Re: Hudson River PCBs Site - Memoranda on GE Sampling Data

Preliminary Comments on GE Review of USGS Water Column Data
February 13, 1998

Subject: Preliminary comments on GE review of USGS water column data **Pjn:** 1182-09

GE Split Samples, Total PCBs USGS vs Congener

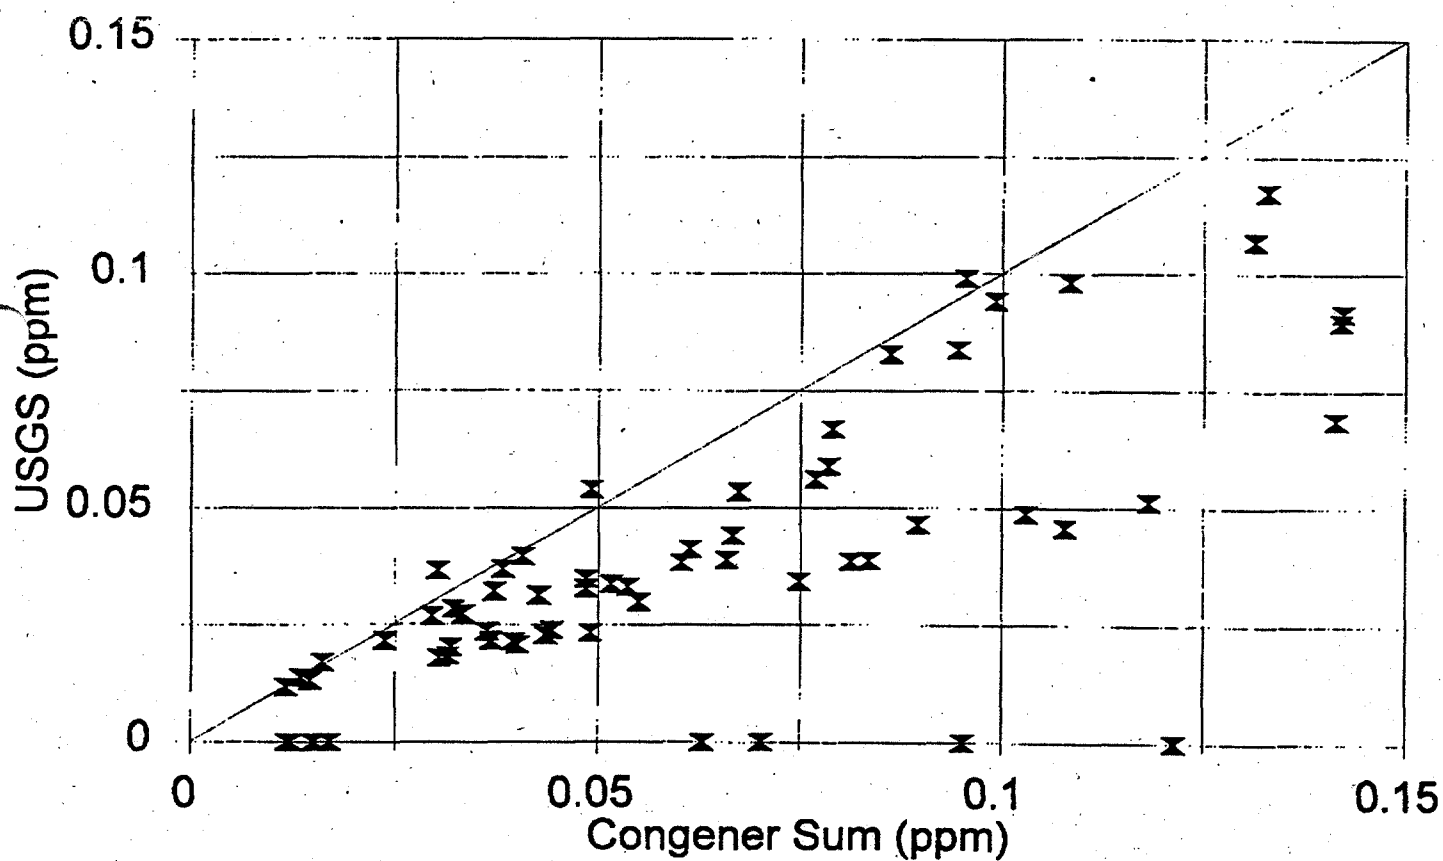
Figure 1 plots the USGS total versus whole-water sum of congeners. In most instances, the USGS result is less than or equal to the sum of congeners. On the other hand, if the USGS results are plotted against the tri- and higher-chlorinated fraction (Figure 2), most samples lie very close to the line of unity, with the exception of 10 samples which were non-detect by USGS methods and reported as zeros.

GE Split Samples, Total PCBs
USGS vs Homologues 3-10

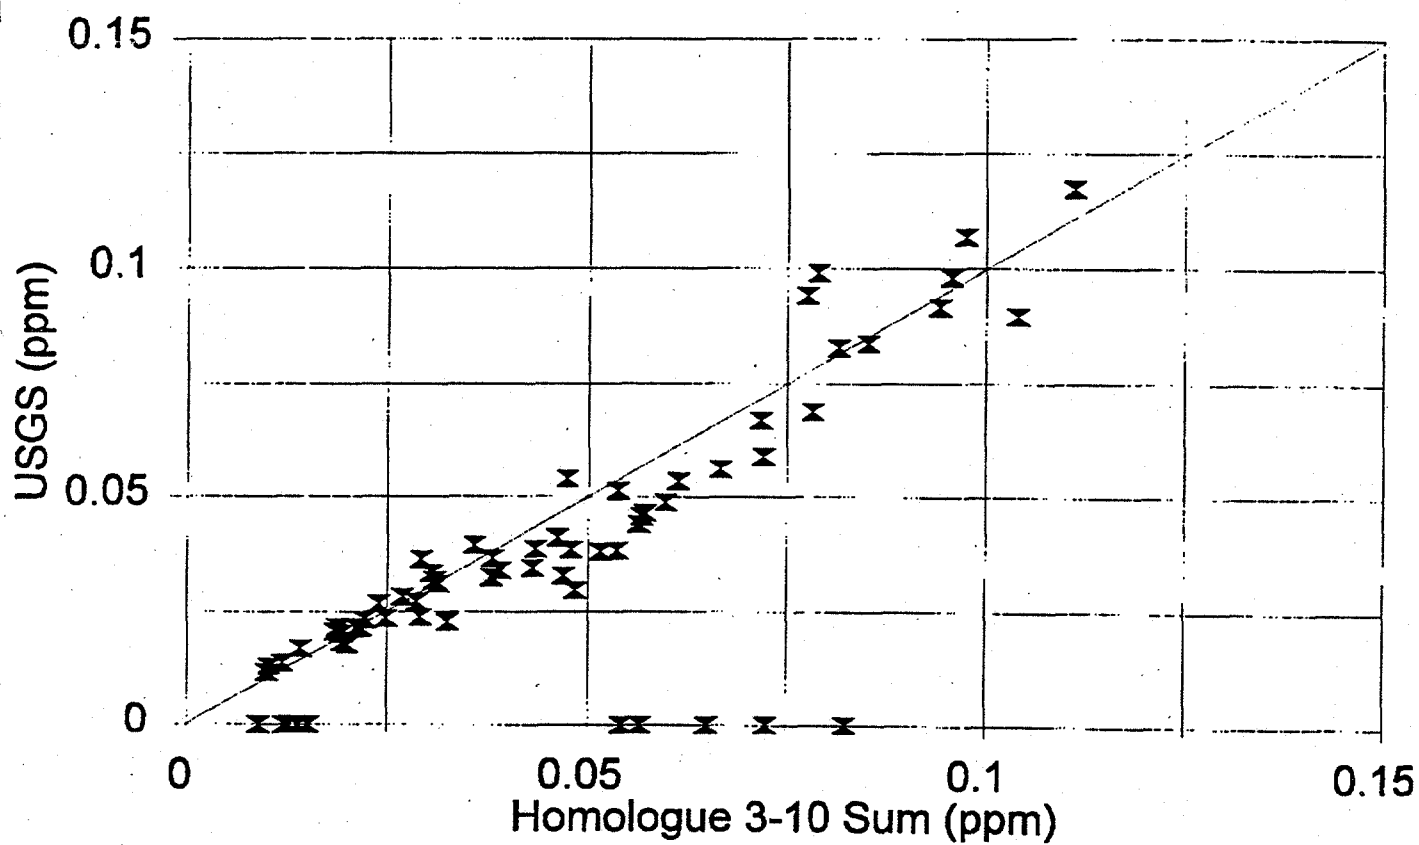
If the zeros are omitted, a regression predicting the tri- and higher-chlorinated homologue sum from USGS results has a slope of 0.92 (with intercept) and 1.03 (no-intercept). In both cases, the slope coefficient is not significantly different from 1. It therefore appears that the USGS results can be taken directly as a reasonable approximation of the sum of tri- and higher-chlorinated homologues.
